ITEM 3

Application Reference	DC/091420
Location:	Marple Library Memorial Park Marple Stockport SK6 6BA
PROPOSAL:	Demolition of existing Marple Library, Marple Clinic and Marple Police Station buildings and erection of leisure and community building (Use Class E, F1, and F2) with associated parking, landscaping, drainage, pedestrian and highways improvements and other supporting infrastructure.
Type Of Application:	Full Application
Registration Date:	14/03/2024
Expiry Date:	13/06/2024 (Extension of Time Agreed)
Case Officer:	Mark Burgess
Applicant:	Stockport Metropolitan Borough Council
Agent:	Stantec

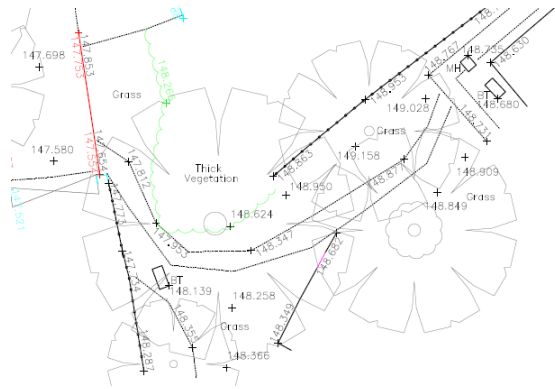
- 1) The layout of the police car park is very tight, with little manoeuvring area provided. It is unclear whether vehicles could be manoeuvred into / out of each parking space and, as such, I would request the submission of vehicle swept-path tracking diagrams to demonstrate that all parking spaces could be accessed.
- 2) The shared path in front of Hollins House is presently accessed from the site access road. The reconfigured car park will, however, result in two parking spaces blocking access to this when in use. Whilst the use of these spaces could be managed, access to for cycles will be restricted. As such, I would recommend that the existing path adjacent to the spaces is widened to allow this to be used by cyclists, as per the plan below.

- 1) Swept path analysis of the existing and proposed Police car park layout has been undertaken and this demonstrates that the proposed car park layout will work, albeit manoeuvring is tight. In addition, GMP consider the layout an improvement over the existing car park.

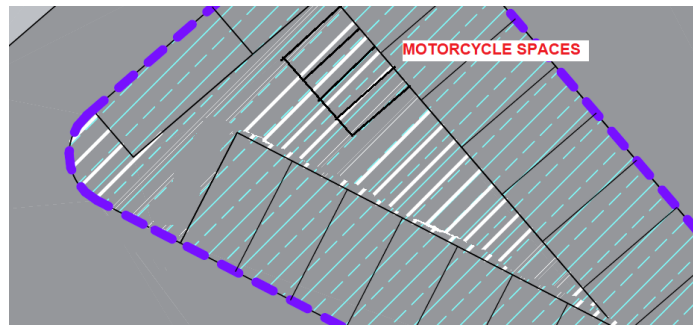
- 6) Whilst the proposal to widen the path between the car park and the path in front of Hollins House so it can be used by cyclists is noted and welcomed, shared use paths should be a minimum of 3m in width. As such, it should be widened from 2.4m to 3m in width, along the lines shown on the drawing below.

- 7) Although it is acknowledged that the site is fairly constrained and it would be beneficial to maximise the number of car parking spaces within the site, it is considered that dedicated motorcycle parking should be provided (as required by Policy T-1 and in line with the adopted standards) and I note that there are locations where it could be provided. One option would be to provide them in the centre of the car park, as shown on the drawing below. As shown, sufficient room is available for 4 no. 1.5m by 2.8m spaces to be provided. By moving the spaces in the central bank of spaces to the south slightly to the south-east, adequate space to access them can also be provided.

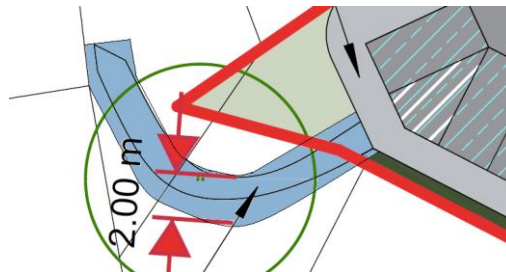
- 8) I note that the revised layout better reflects the existing pedestrian route between the site and Parkfield Avenue. This, however, is narrow and not properly surfaced. Noting that it will be a key route to the west (and will link with the new ramp into Hollins Lane car park) it is considered that this should be improved. It should therefore be shown to be widened to 2m and surfaced in bitmac, along the lines shown on the drawing below. The drawing should be based on the topographic survey for this location, however, as the oobe drawings do not accurately reflect what is on the ground (notably the drawing shows the tree in the path which is not the case).

Willmott Dixon, Drawing Title: Proposed External Lighting Layout, 16.02.24, Drawing No. TAC-ZOXX-DR-E-9005, Rev P01.

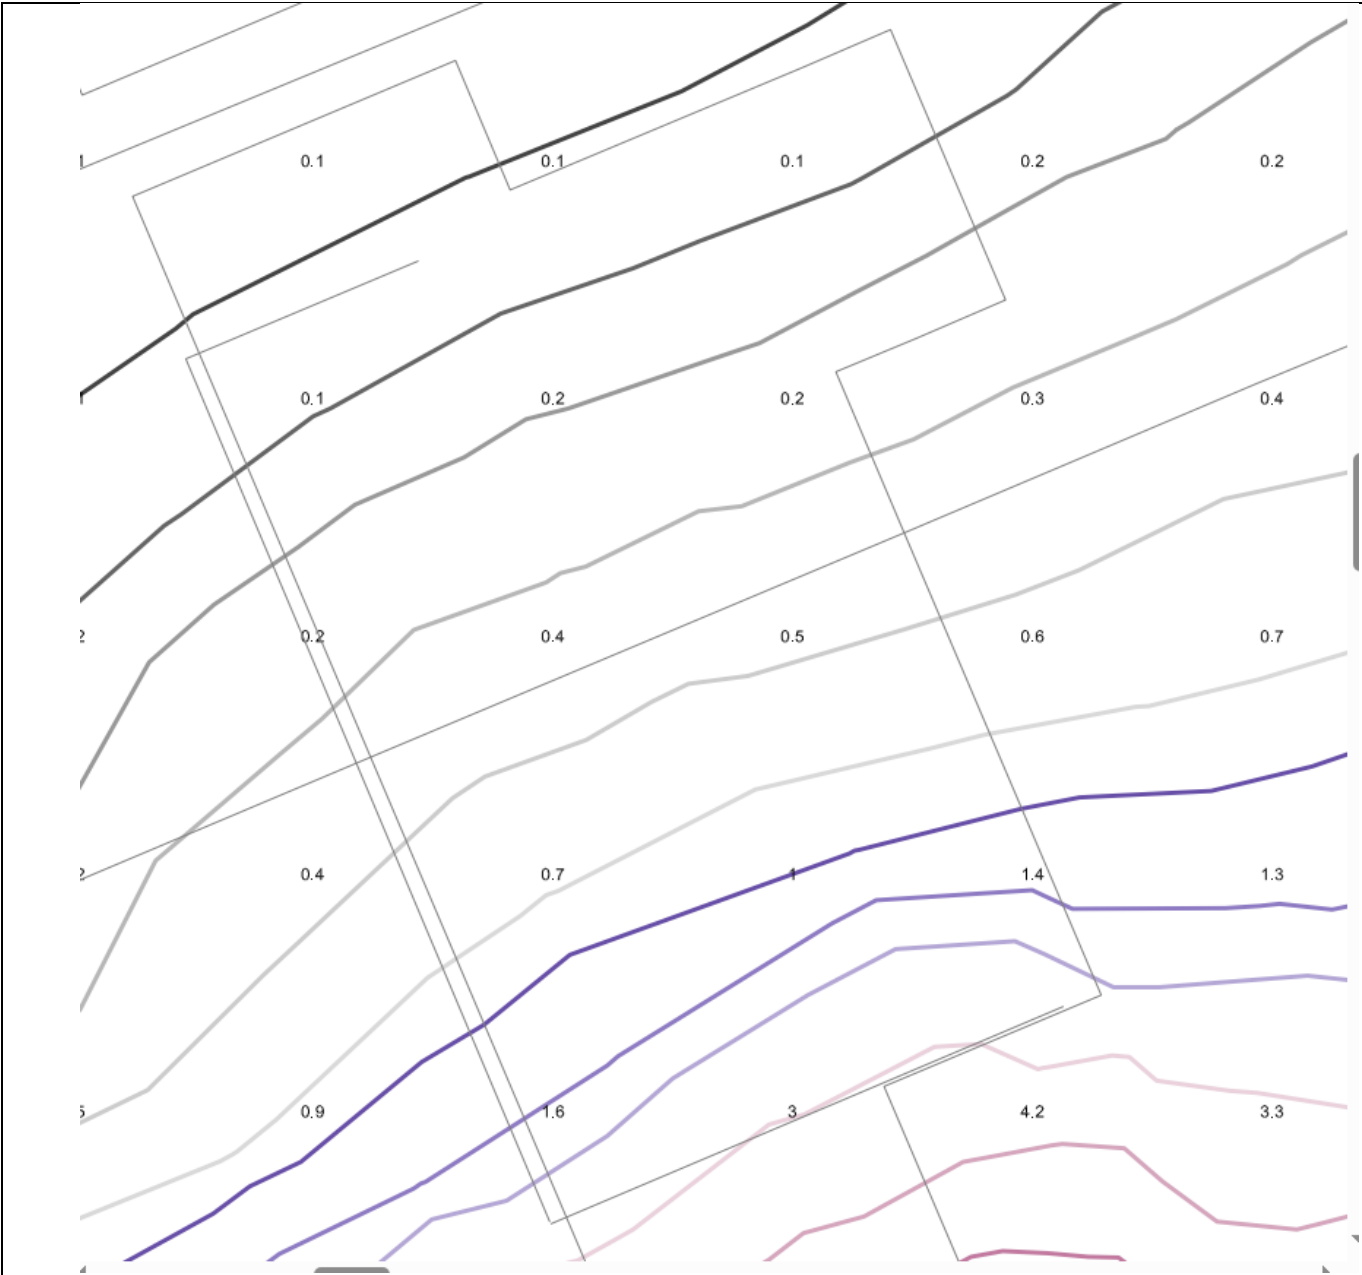
Assessment of the applicant's illumination assessment drawing; the lux levels at the residential windows of 9 & 11 Parkfield Avenue, appear to exceed the Institute of Lighting Professionals, *Guidance Note 01/21, The Reduction of Obtrusive Light*, and recommended Maximum Values of Light Parameters for the Control of Obtrusive Light – Light intrusion/ nuisance. The maximum value of vertical illuminance on premises, E3 Suburban, Pre-curfew 10 and post-curfew 2 on the south-east elevation of no. 11 Parkfield Avenue.

RECEPTORS 13 & 15 Parkfield Avenue

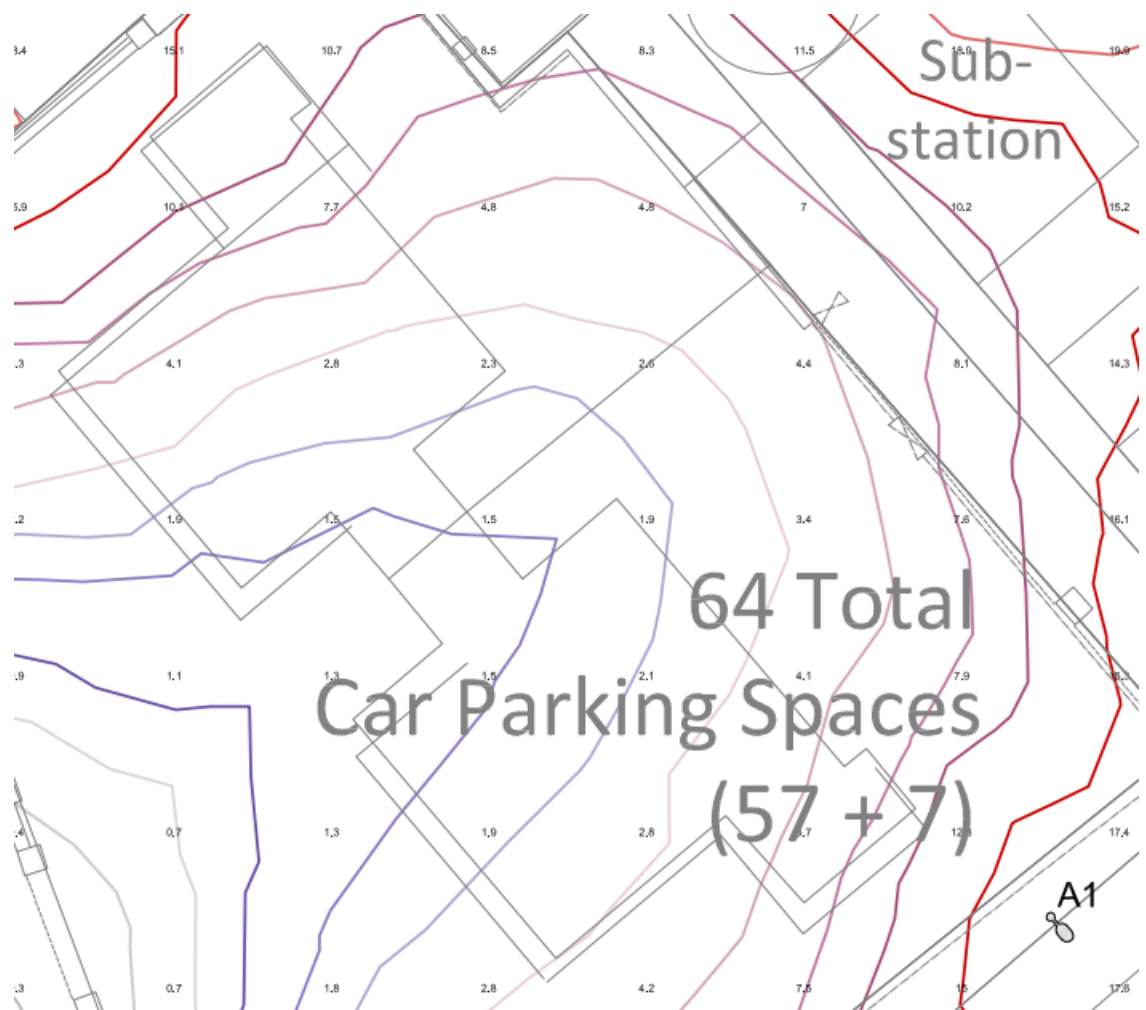
Assessment of the applicant's illumination assessment drawing; the lux levels at the residential windows of 13 & 15 Parkfield Avenue, appear to exceed the Institute of Lighting Professionals, *Guidance Note 01/21, The Reduction of Obtrusive Light*, and recommended Maximum Values of Light Parameters for the Control of Obtrusive Light – Light intrusion/ nuisance. The maximum value of vertical illuminance on premises, E3 Suburban, Pre-curfew 10 and post-curfew 2.

Figure 7: Potential ASHP compound locations.

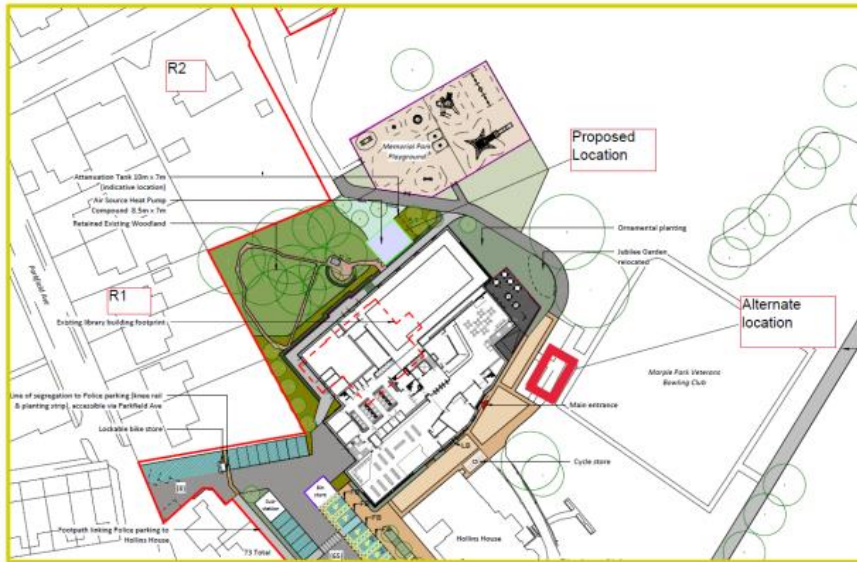
The residential houses on Parkfield Avenue and Station Road are the closest noise sensitive receptors to the proposed development. Identified as R1 and R2 in Figure 7 above.
